## **APPENDIX C:**

### **CITY OF MALIBU CDP APPLICATION REVIEW CORRESPONDENCES**

**SMC MALIBU CAMPUS / SHERIFF'S SUBSTATION**  
 MALIBU CA, 90265

**Subject: Second Engineering Geology and Seismology Review for  
Santa Monica College – Two Story Classroom Bldg. & Sheriff Substation  
23525 Civic Center Way, Malibu, CA  
CGS Application No. 03-CGS1600 DSA Application No. 03-115508**

**1 FIRE ACCESS PLAN**  
 G102 REF: 11/A5 SCALE: 1" = 30'-0"

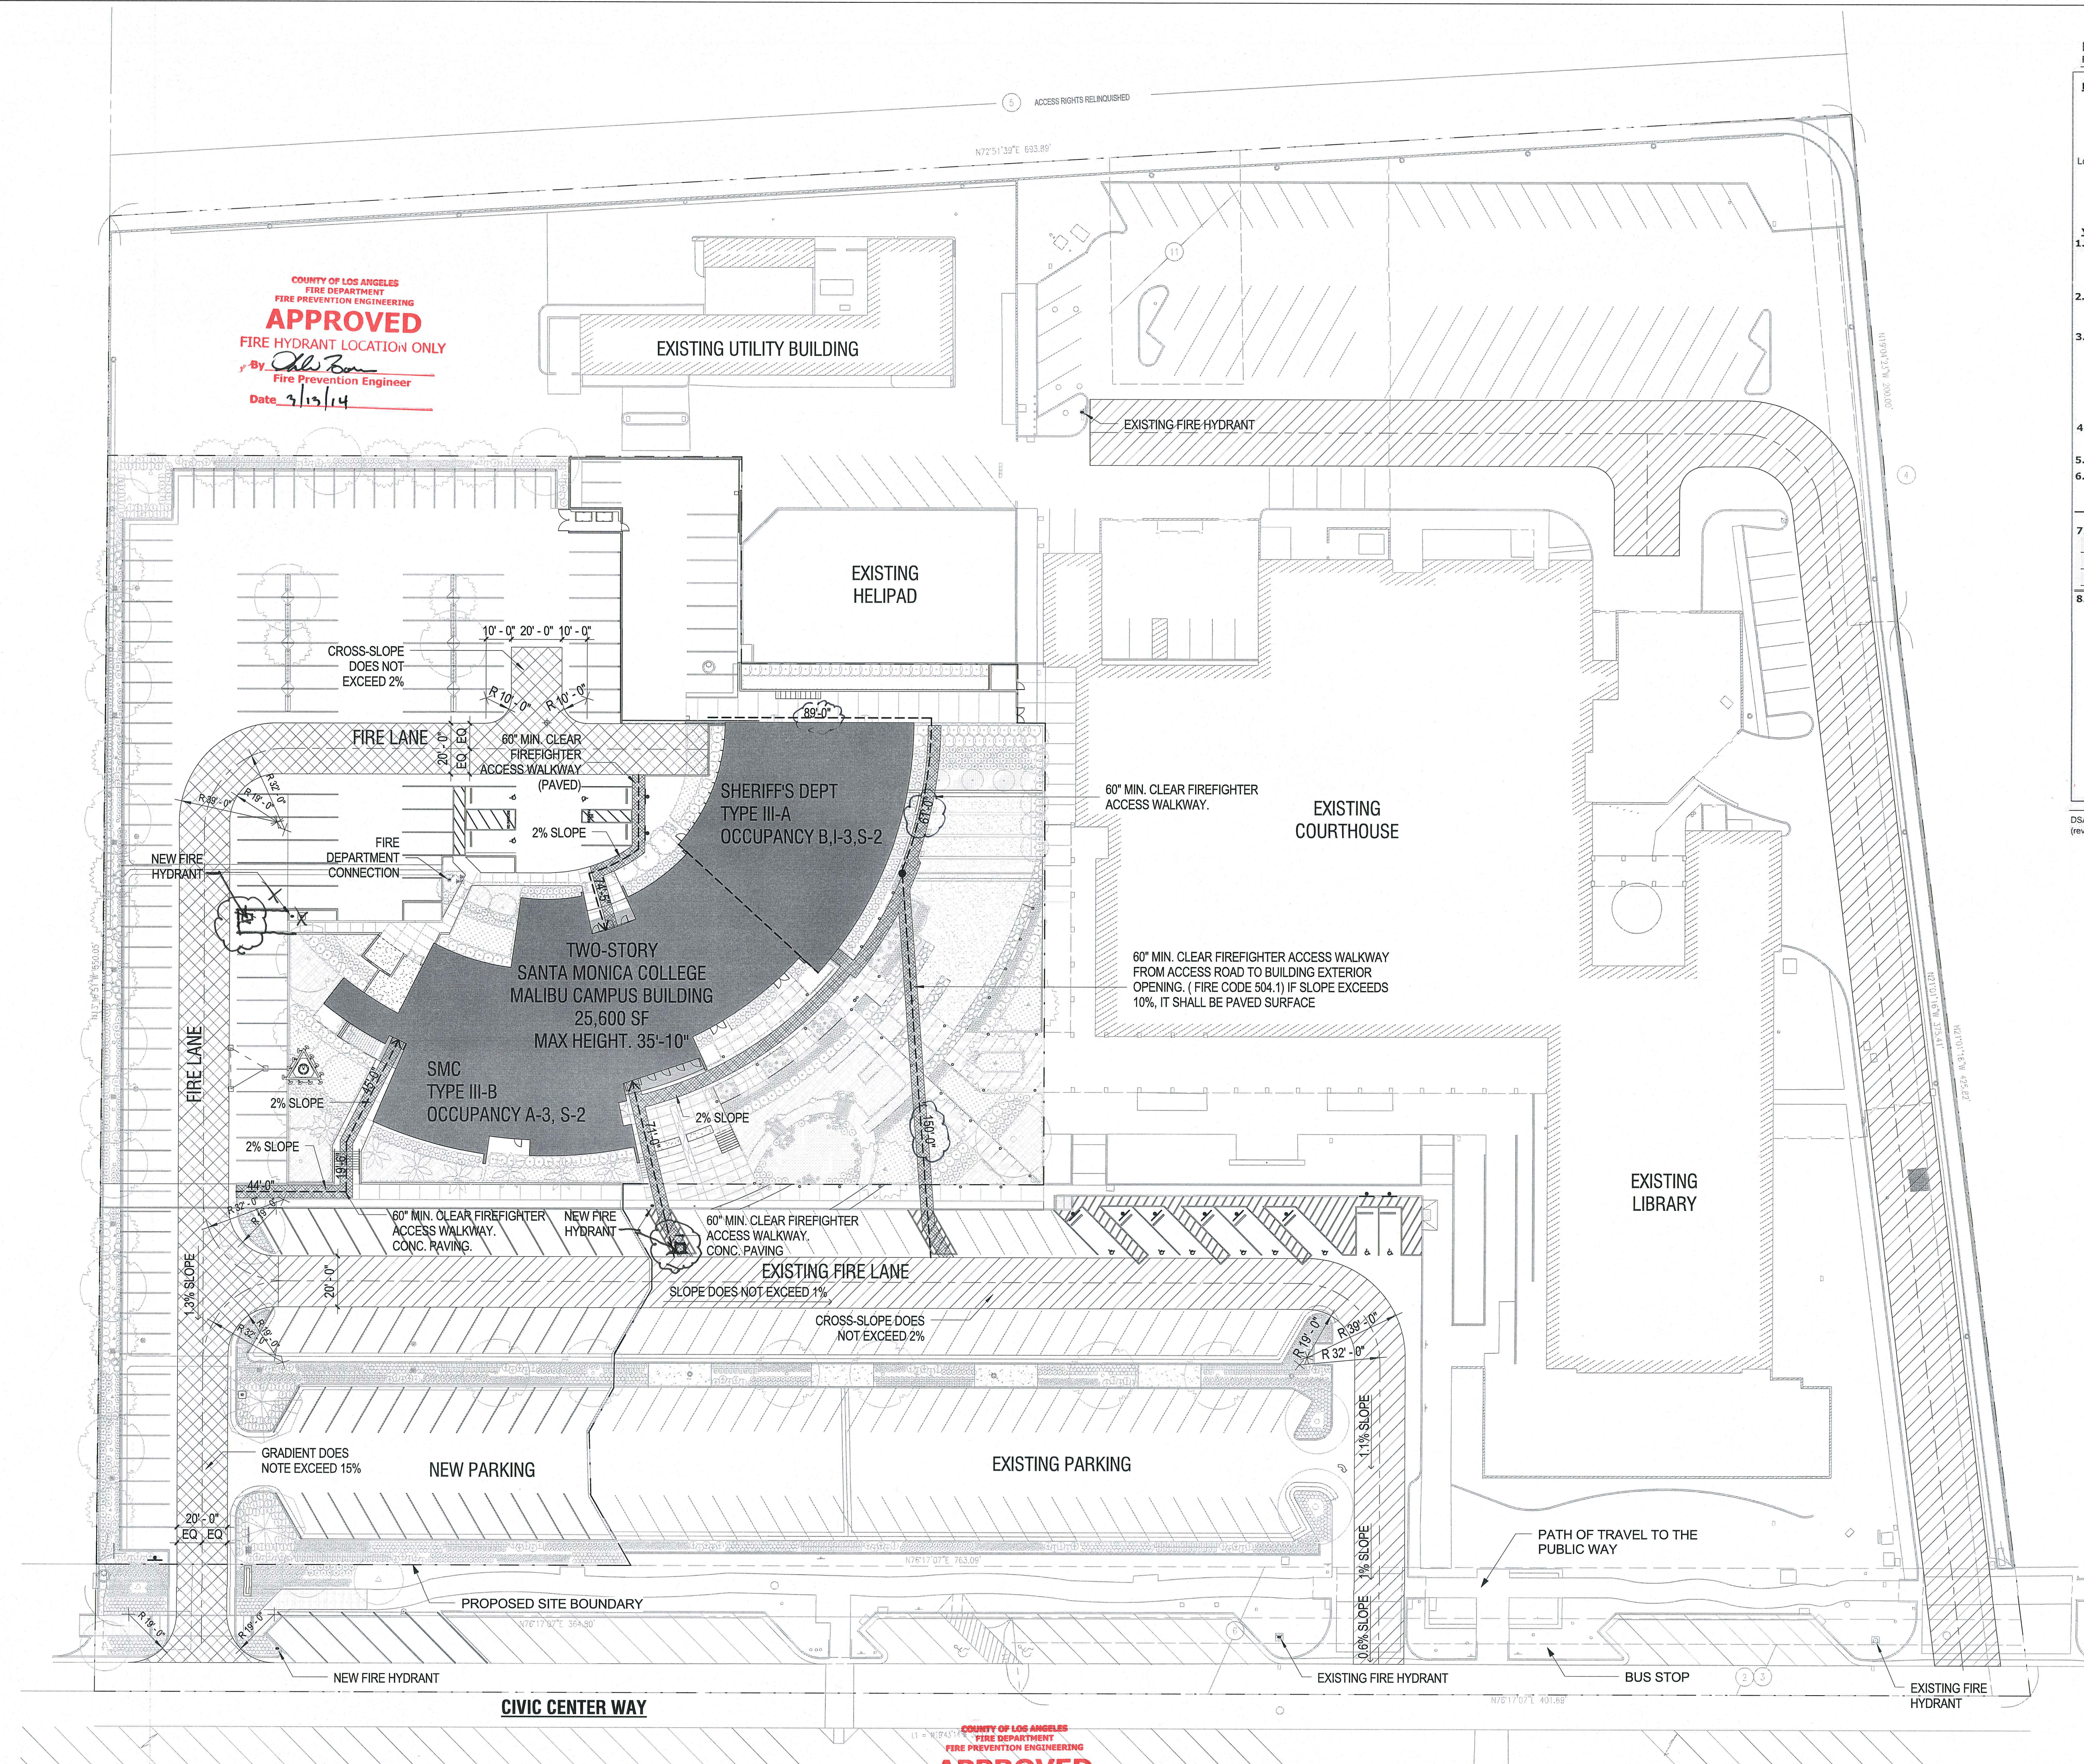
COUNTY OF LOS ANGELES  
 FIRE DEPARTMENT  
 FIRE PREVENTION ENGINEERING  
**APPROVED**  
 ACCESS REQUIREMENTS ONLY  
 By **[Signature]**  
 Fire Prevention Engineer  
 Date **7/13/14**
